Reply point by point

The authors present an interesting approach to increase knowledge about the internal structure and hydraulic processes of rock glaciers. The paper is well written, description of the site, methods and results seem complete, and the results are very promising. I like the original and minimalistic approach to collect and preserve enough water for the experiment.

Fig 3:

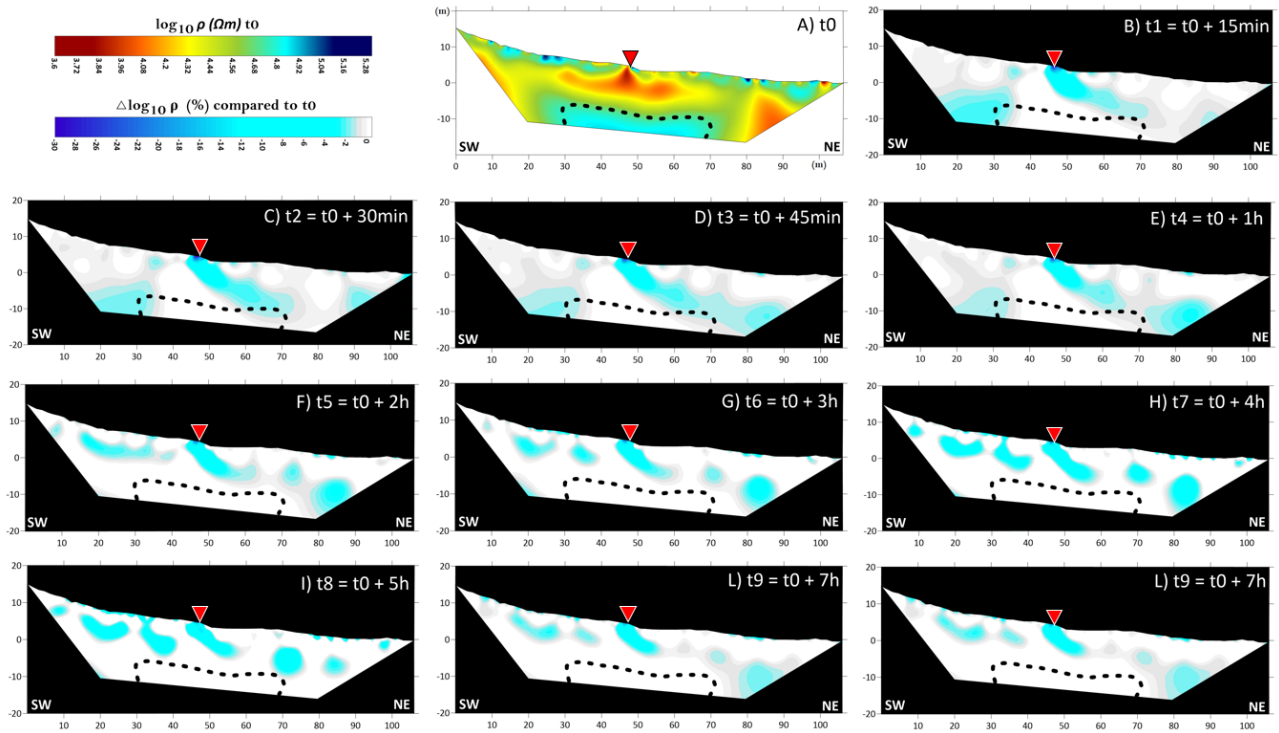
- I would prefer to see the tomogram t0 plotted with a logarithmic colour scale (common standard in the community).

- as mentioned before I strongly recommend to plot the resistivity change based on logarithmic values, which will smooth the overall resistivity change and balance changes in low and high resistivity zones with a probable positive effect on interpretability...

- indicate the point of injection in Fig. 3A (as far as I understand it is in the center of the profile) --> how do you explain resistivity decrease upslope of this point?? Snowmelt? Seasonal active layer thaw?

Reply: In the revised manuscript we will plot it in logarithmic scale.

Reply: In the revised manuscript we will plot the resistivity change based on logarithmic values, as discussed in the reply to the first general comment.

Reply: We thank the reviewer for the useful suggestion and in the revised manuscript we will plot the tomograms with an indication of the injection point. Regarding the negative % resistivity changes upslope the injection point, we presented the following explanation in lines 160-164: "...the presence of boulders and large rocks at various depths can lead to local reductions of the permeable area, causing funnel flow, and/or a splitting of flow paths (Hartmann et al., 2020). Splitting flow paths, due to the presence of large boulders, may have determined the infiltration of some injected water along the south-west direction and a local accumulation upslope of the injection point, which resulted in the observed negative resistivity variations." During the infiltration experiment there was no snow cover on the rock glacier and, since the infiltration experiment was carried out in few hours, we think that we can exclude any link with active layer thawing. Moreover, as specified in line 104, no rain or uncontrolled water contribution happened during the 24 hours of the experiment.
